LANCASTER ESTATES SUBDIVISION, PHASE TWO

APPLICATION NUMBER 6 DATE May 3, 2018

DETAIL SITE PLAN

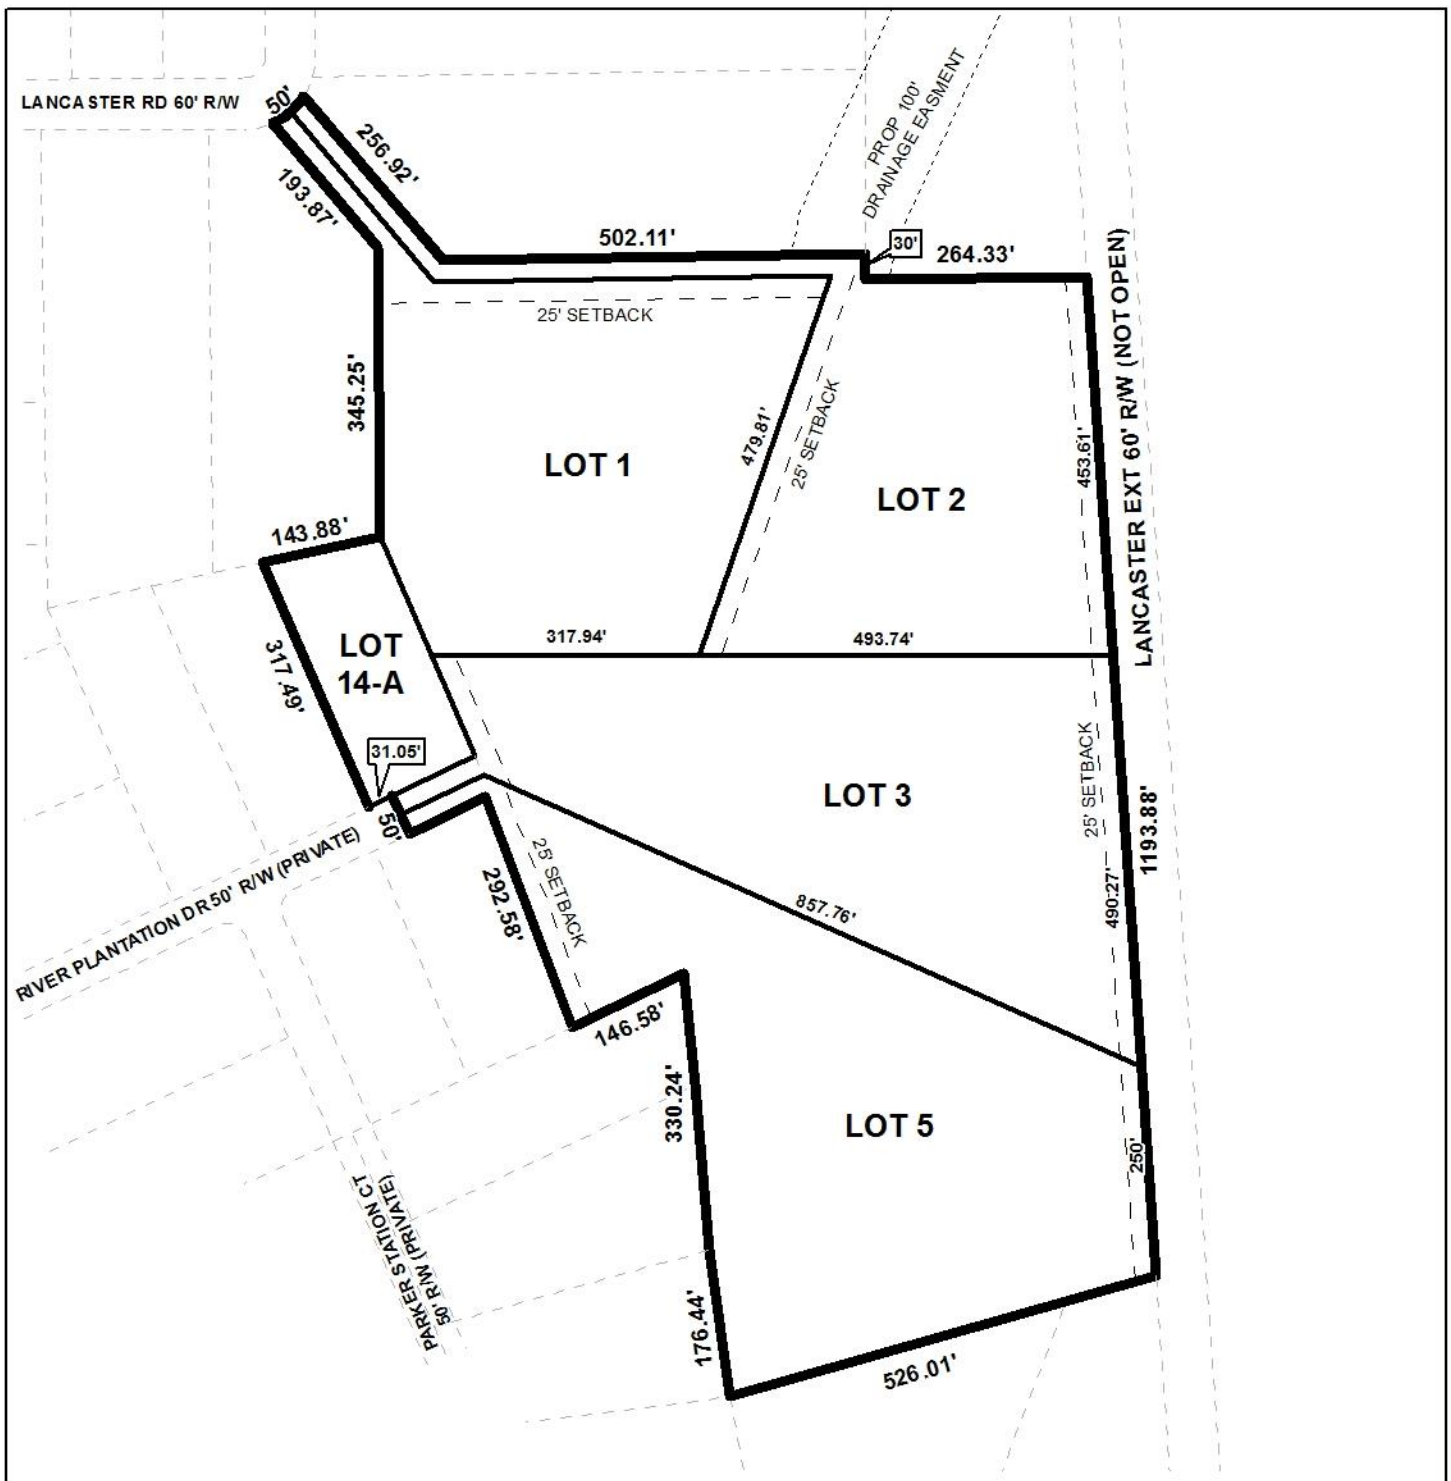
The 25' minimum building setback line is depicted on Lots 1 – 4 where each lot is at least 60' in width and this should be retained on the Final Plat. The plat should be revised to also depict the 25' minimum building setback line for Lot 14-A.

The lot areas in both square feet and acres are depicted on the preliminary plat and should be retained on the Final Plat, or a table should be furnished on the Final Plat providing the same information.

- 4) retention of the 25' minimum building setback line for Lots 1 – 4 where each lot is at least 60' wide;
- 5) revision of the plat to illustrate the 25' minimum building setback line for Lot 14-A;

- 6) retention of the lot size labels in both square feet and acres, or the furnishing of a table on the Final Plat providing the same information;
- 7) placement of a note on the Final Plat stating that any lots which are developed commercially and adjoin residentially developed property must provide a buffer, in compliance with Section V.A.8. of the Subdivision Regulations;
